# UNITED STATES PATENT AND TRADEMARK OFFICE

10/552,376

Hua Chen

<b>Office Action Summary</b>	<b>Application No.</b> 10/552,376	<b>Applicant(s)</b> CHEN, HUA	
	<b>Examiner</b> Christopher Verdier	<b>Art Unit</b> 3745

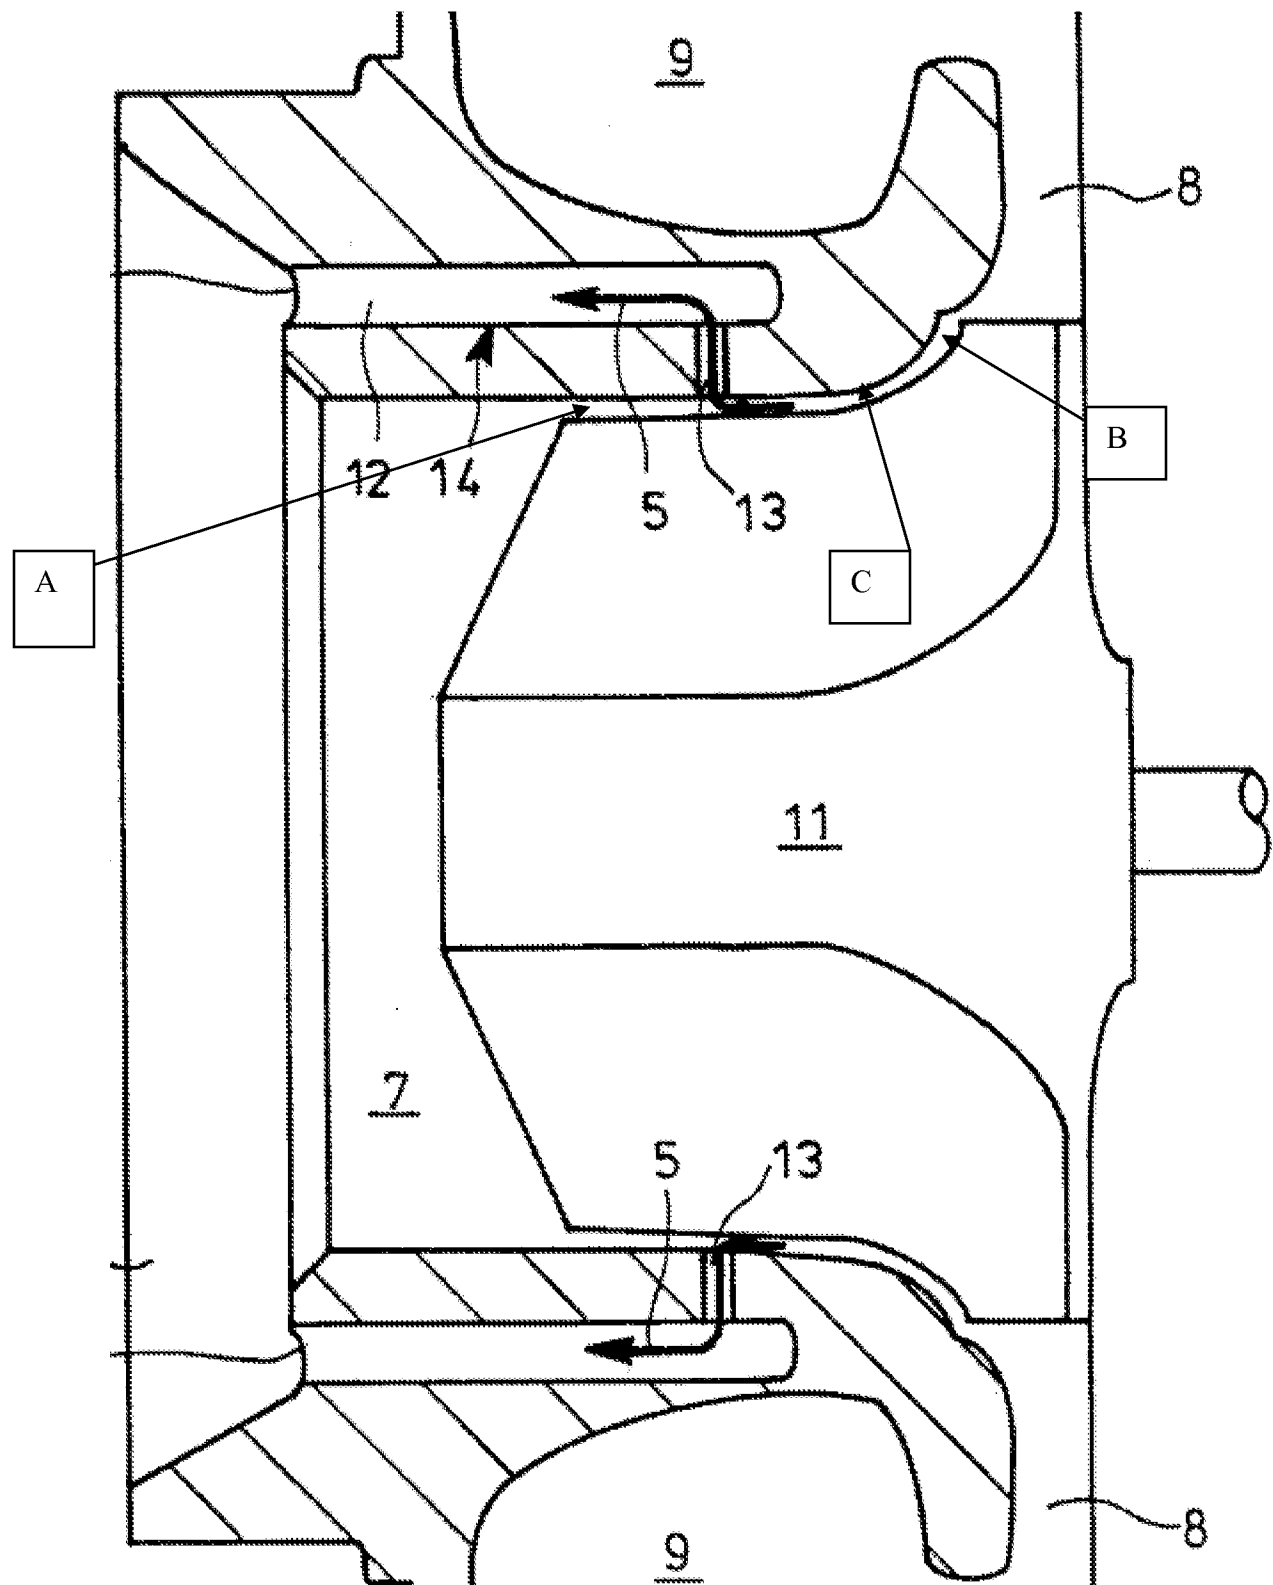
Claims 1, 15/1, and 18 are rejected under 35 U.S.C. 102(b) as being anticipated by Mitsubori 5,246,335 (figure 2). Disclosed is a compressor comprising a compressor wheel having a hub 11, unnumbered free-ended compressor blades and being mounted for rotation on an unnumbered shaft, each blade being characterized by a free-ended outer edge, an upstream leading edge and a downstream trailing edge, and a shroud 4 mounted adjacent and around the outer edges of the compressor blades and defining a gas flow path between the shroud and the hub from a compressor inlet 6 to a diffuser outlet 8, through which the blades rotate with respect to the shroud, wherein in cross-section the shroud forms a surface A along the flow path, the surface being characterized by a profile that includes a relative discontinuity B in the region of the trailing edge, wherein the discontinuity forms a downstream-facing blocking face adapted to impede an upstream flow of gas between the shroud and the wheel, the blocking face extending across the flow path to form a sharp edge connecting the blocking face to a smoothly curving surface C along the gas flow path upstream of the blocking face. The compressor is included

with a turbocharger. The discontinuity is in the form of a groove. Note the annotated figure below.

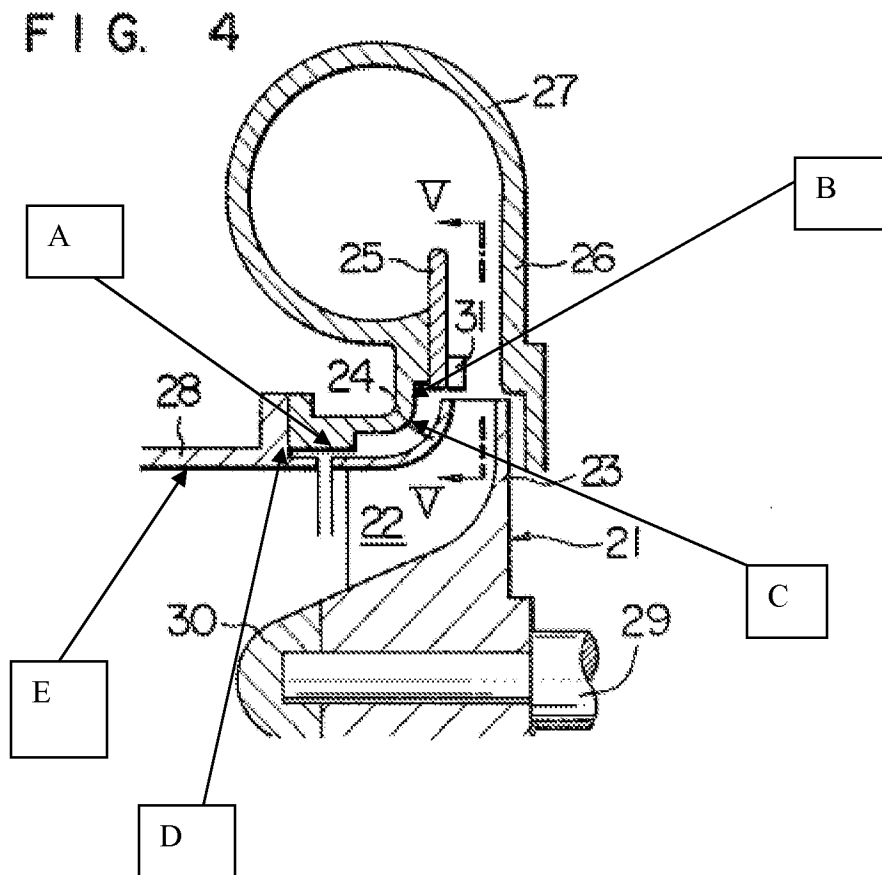
Claims 1, 4, 5, 6, 9, 11, 12/6, 13/6, 14/6, 15/6, 12/9, 13/9, 14/9, 12/4, 13/4, 14/4, 15/1, 15/4, 15/11, and 18 are rejected under 35 U.S.C. 103(a) as being unpatentable over Yoshinaga 4,395,197 in view of Jones 3,893,787. Yoshinaga disclosed a compressor substantially as claimed, comprising a compressor wheel 21 having a hub 1, compressor blades 22 and being mounted for rotation on a shaft 29, each blade being characterized by an outer edge, an upstream leading edge and a downstream trailing edge, and a shroud 27/28 mounted adjacent (note that adjacent does not require that two elements be immediately next to one another) and around the outer edges of the compressor blades and defining a gas flow path between the shroud and the hub from a compressor inlet to a diffuser outlet, through which the blades rotate with respect to the shroud, wherein in cross-section the shroud forms a surface A along the flow path, the surface being characterized by a profile that includes a relative discontinuity B in the region of the trailing edge, wherein the discontinuity forms a downstream-facing blocking face adapted to impede an upstream flow of gas between the shroud and the wheel, the blocking face extending across the flow path to form a sharp edge connecting the blocking face to a smoothly curving

surface C along the gas flow path upstream of the blocking face. The cross-section profile of the shroud surface along the flow path is further characterized by a second relative discontinuity D that is in the region of the leading edge, wherein the second relative discontinuity forms a second-discontinuity downstream-facing blocking face adapted to impede an upstream flow of gas between the shroud and the wheel, the second-discontinuity blocking face extending across the flow path to form a second-discontinuity sharp edge connecting the second blocking face to a second-discontinuity smooth surface E upstream of the second-discontinuity blocking face. The second discontinuity is located upstream of the leading edge of the wheel blades. The second discontinuity is spaced from the leading edge of the wheel blades by a distance of the same order as the axial clearance of the trailing edge from the compressor housing. The or each downstream-facing blocking face comprises a planar surface cut into the curving surface. The second-discontinuity downstream-facing blocking face comprises a planar surface cut into the curving surface, and the planar surface is perpendicular to the axis of the shaft. The radial extent of the second discontinuity is of the same order as the radial clearance between the trailing edge and the housing. The sizes of the first and second discontinuities are closely similar. The discontinuity is in the form of a groove. The shapes of the first and second discontinuities are closely similar. Concerning claim 15, the term “turbocharger” is recited in the preamble of the claim and has not been given patentable weight. A preamble is generally not accorded any patentable weight where it merely recites the purpose of a process or the intended use of a structure, and where the body of the claim does not depend on the preamble for completeness but, instead, the process steps or structural limitations are able to stand alone. See *In re Hirao*,

535 F.2d 67, 190 USPQ 15 (CCPA 1976) and *Kropa v. Robie*, 187 F.2d 150, 152, 88 USPQ 478, 481 (CCPA 1951). Note the annotated figure below.

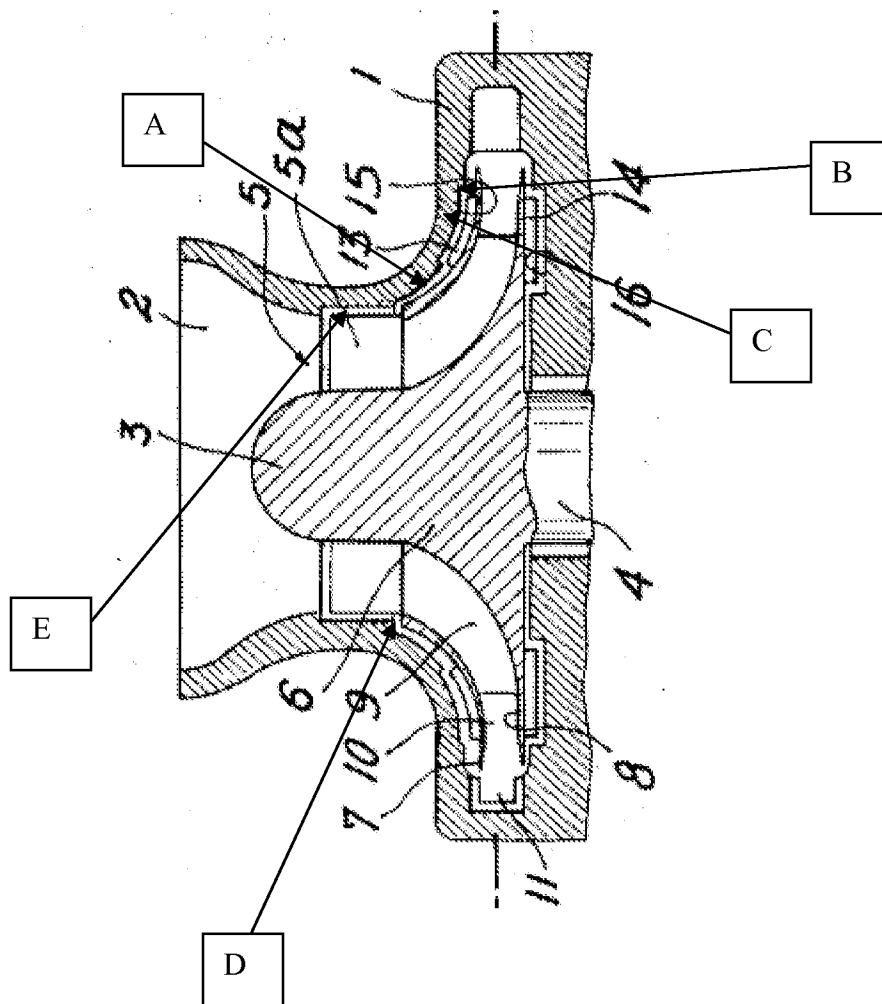
Claims 1, 4, 5, 9, 11, 13/9, 14/9, 13/4, 14/4, 15/1, 15/4, 15/11, and 18 are rejected under 35 U.S.C. 103(a) as being unpatentable over Fabri 3,824,029 in view of Jones 3,893,787. Fabri discloses a compressor substantially as claimed, comprising a compressor wheel 3/6 having a hub 3 and compressor blades 9 and being mounted for rotation on a shaft 4, each blade being characterized by an outer edge, an upstream leading edge and a downstream trailing edge, and a shroud 1 mounted adjacent (note that adjacent does not require that two elements be immediately next to one another) and around the outer edges of the compressor blades and defining a gas flow path between the shroud and the hub from a compressor inlet to a diffuser outlet, through which the blades rotate with respect to the shroud, wherein in cross-section the shroud forms a surface

A along the flow path, the surface being characterized by a profile that includes a relative discontinuity B in the region of the trailing edge, wherein the discontinuity forms a downstream-facing blocking face adapted to impede an upstream flow of gas between the shroud and the wheel, the blocking face extending across the flow path to form a sharp edge connecting the blocking face to a smoothly curving surface C along the gas flow path upstream of the blocking face. The cross-section profile of the shroud surface along the flow path is further characterized by a second relative discontinuity D that is in the region of the leading edge, wherein the second relative discontinuity forms a second-discontinuity downstream-facing blocking face adapted to impede an upstream flow of gas between the shroud and the wheel, the second-discontinuity blocking face extending across the flow path to form a second-discontinuity sharp edge connecting the second blocking face to a second-discontinuity smooth surface E upstream of the second-discontinuity blocking face. The second discontinuity is located upstream of the leading edge of the wheel blades. The or each downstream-facing blocking face comprises a planar surface cut into the curving surface. The second-discontinuity downstream-facing blocking face comprises a planar surface cut into the curving surface, and the planar surface is perpendicular to the axis of the shaft. The sizes of the first and second discontinuities are closely similar. The shapes of the first and second discontinuities are closely similar. Concerning claim 15, the term “turbocharger” is recited in the preamble of the claim and has not been given patentable weight. A preamble is generally not accorded any patentable weight where it merely recites the purpose of a process or the intended use of a structure, and where the body of the claim does not depend on the preamble for completeness but, instead, the process steps or structural limitations are able

to stand alone. See *In re Hirao*, 535 F.2d 67, 190 USPQ 15 (CCPA 1976) and *Kropa v. Robie*, 187 F.2d 150, 152, 88 USPQ 478, 481 (CCPA 1951). Note the annotated figure below.
